Access Compliance Report

(Curb Ramps)

Intersection ID: 8204	Main Street: BEATTIES_FORD_RD	Cross Street: CATHERINE_SIMMONS_AV	Location: NE
ADA ID: CCD61739C98D	Ramp Type: PerpDiag	Initial Pass/Fail: Fail	Overall Compliance: No
Codes/Mitigation Info/Possible Solution			Severity Score: 10
			Field Measurements/Component Compliance

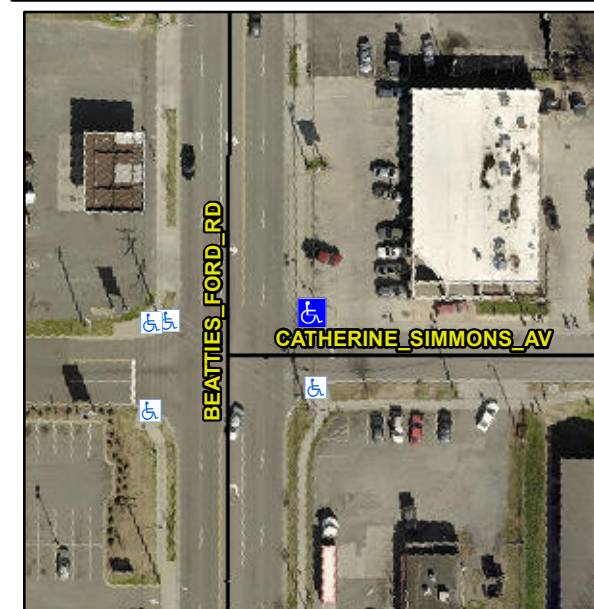
Not Found, R304.5.1, R304.5.3

Compliance	Description	Data	Compliance	Description	Data
N/A	Ramp Length (in)	84.5	Yes	Ramp Slope (%)	7.7
No	Ramp Width (in)	40.5	No	Ramp XSlope (%)	3.5
N/A	Flare Type LT	N/A	N/A	Flare Type RT	N/A
N/A	Flare Slope LT (%)	N/A	N/A	Flare Slope RT (%)	N/A
N/A	Flare Traversable LT?	N/A	N/A	Flare Traversable RT?	N/A
N/A	Landing Length (in)	N/A	N/A	DWS Provided?	N/A
N/A	Landing Width (in)	N/A	N/A	DWS Contrast?	N/A
N/A	Landing Slope (%)	N/A	N/A	DWS Length (in)	N/A
N/A	Landing X Slope (%)	N/A	N/A	DWS Full Width?	N/A
N/A	Landing Curb? (Y/N)	N/A	N/A	DWS Offset (in)	N/A
N/A	Shared Landing?	N/A			
N/A	Gutter Ponding?	N/A	N/A	Gutter Slope (%)	N/A
N/A	Gutter Lip Ht (in)	N/A	N/A	Gutter X Slope (%)	N/A
N/A	Painted X Walk1?	No	N/A	Painted X Walk2?	No
	X Walk 1 Direction	To W		X Walk 2 Direction	To S
N/A	X Walk 1 Width (in)	N/A	N/A	X Walk 2 Width (in)	N/A
	X Walk 1 Slope (%)	0.0		X Walk 2 Slope (%)	1.6
	X Walk 1 X Slope (%)	0.2		X Walk 2 X Slope (%)	1.2

Remove & Replace Curb Ramp With Two New Directional Ramps or Equivalent.
